DRAINAGE LETTER FOR STERLING RANCH SKETCH PLAN AMENDMENT

Job No. 1183.34

SKP235

DRAINAGE MAP

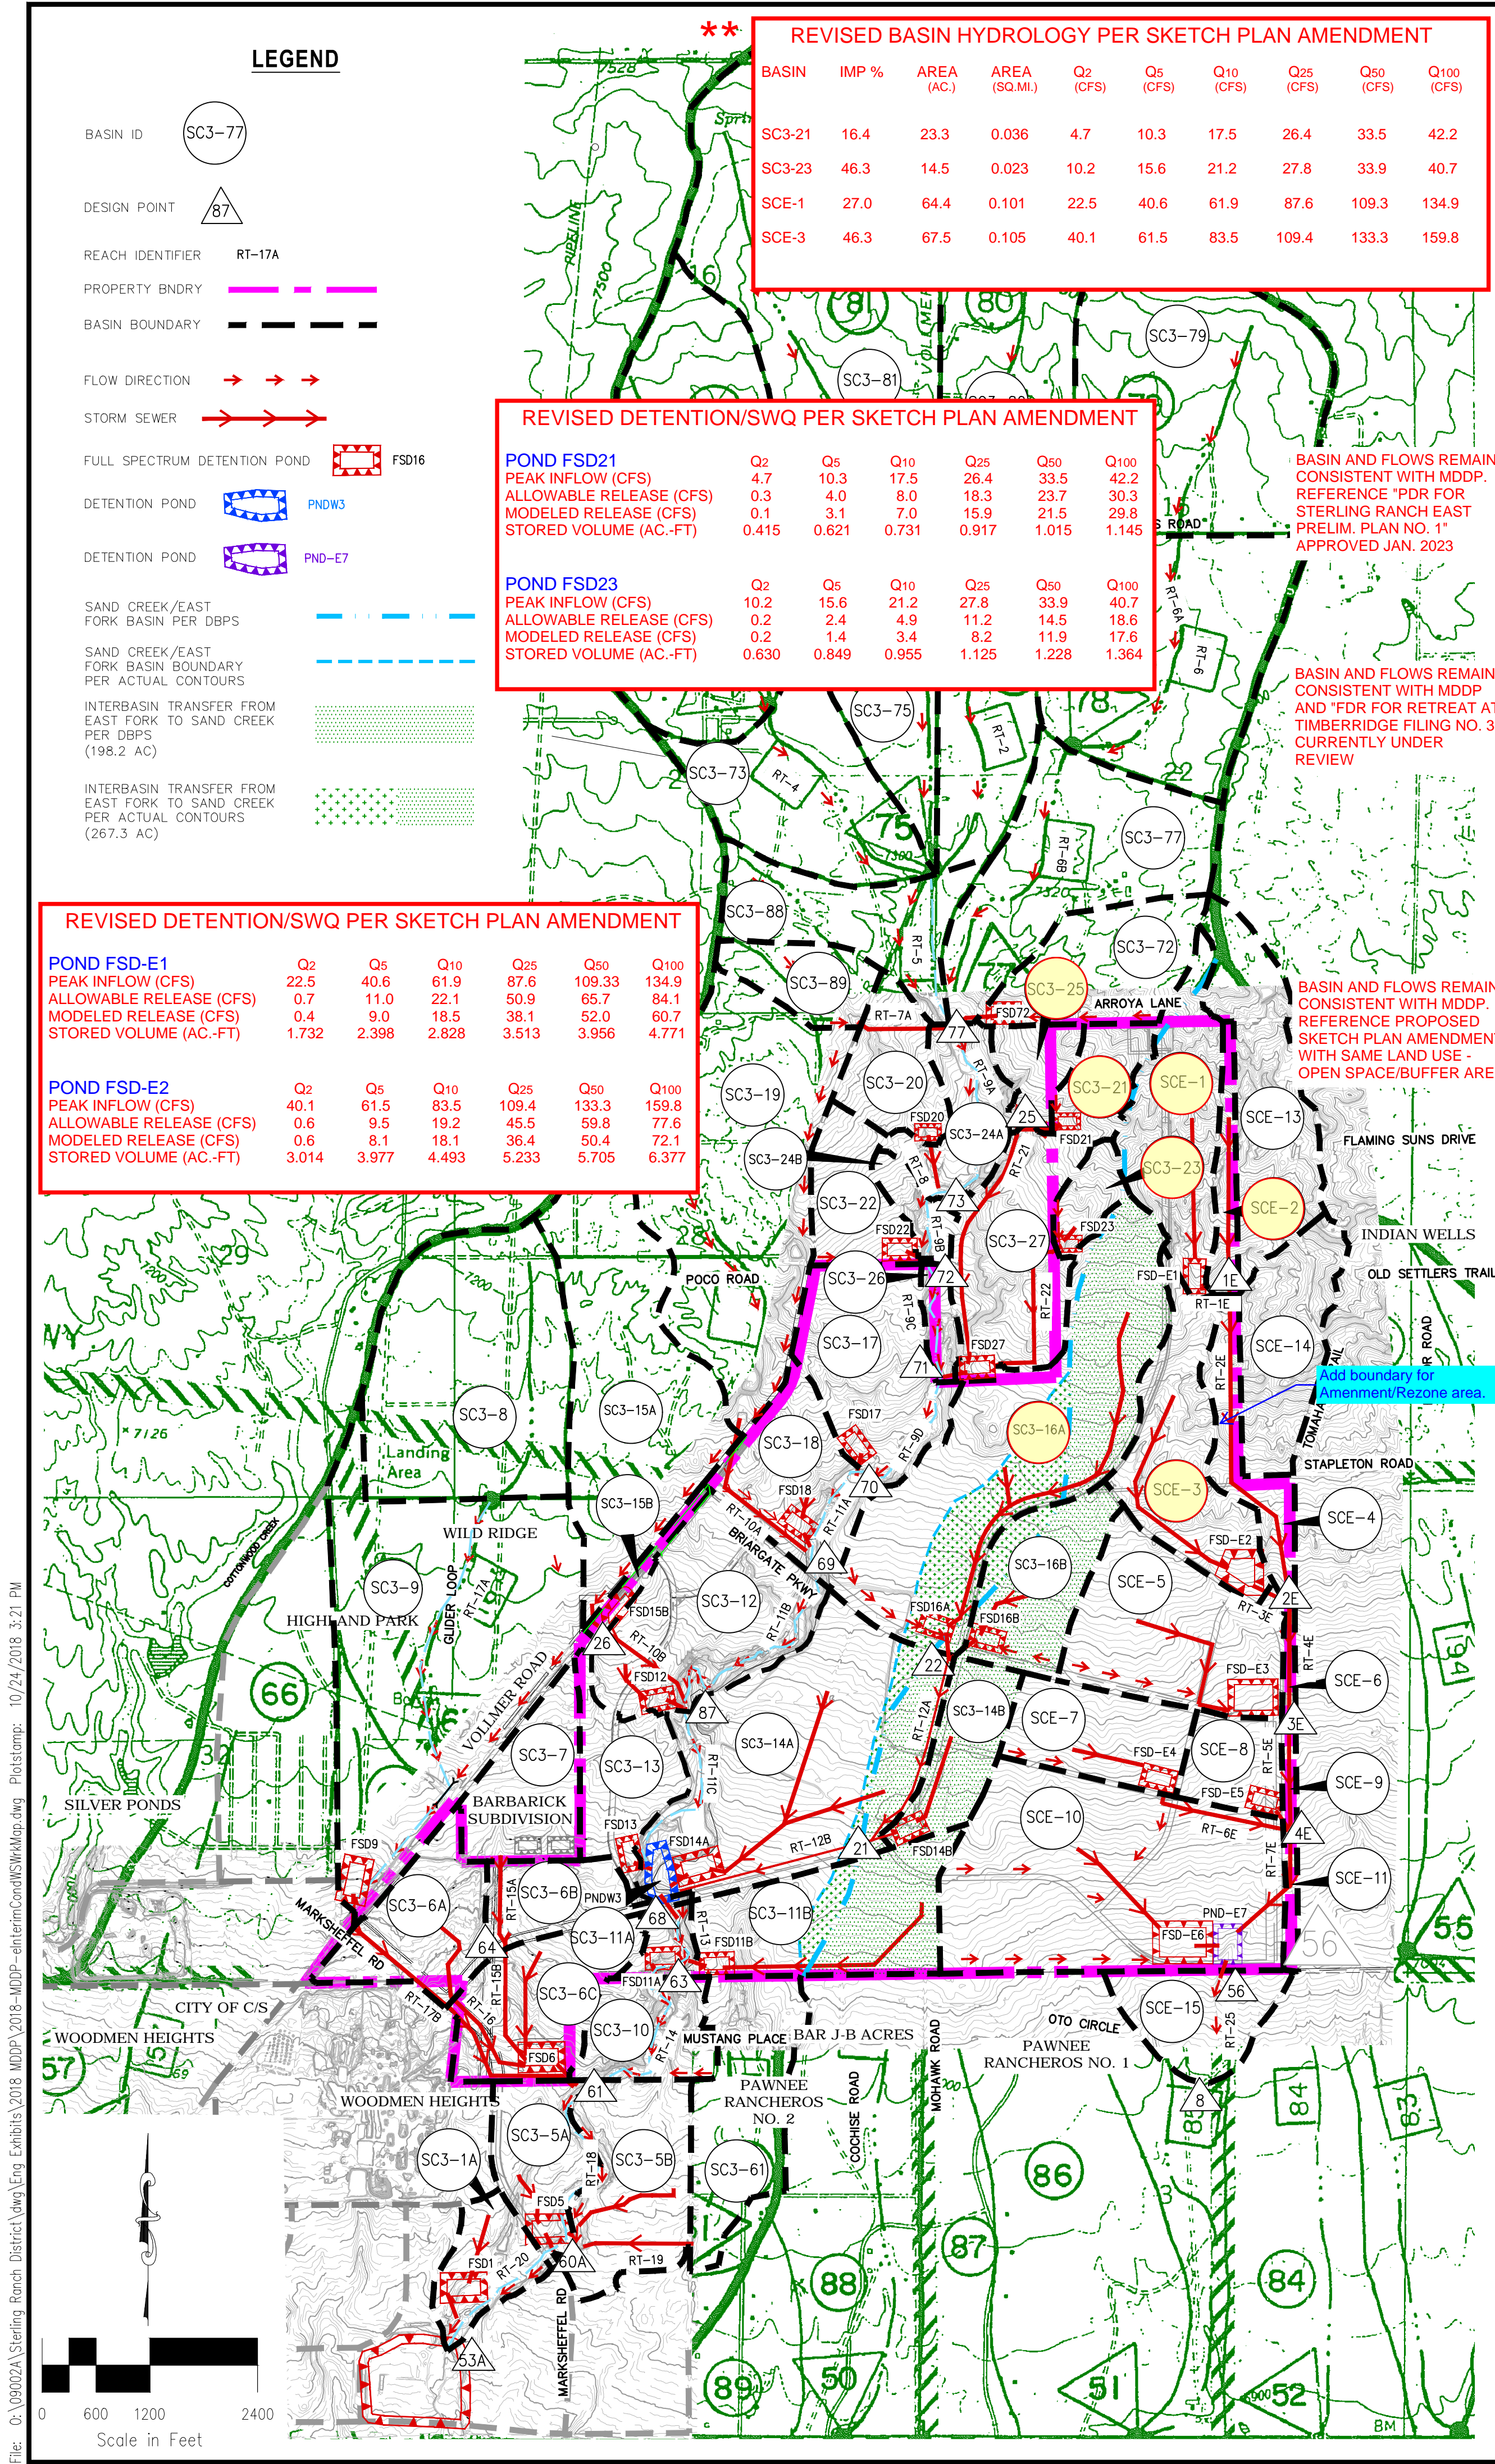
Add boundary for Amenment/Rezone area.

Discuss impact to storm sewer system and trunk main in the basin from the increased density. State the change in peak flows at DP1E.

Please add SC3-25
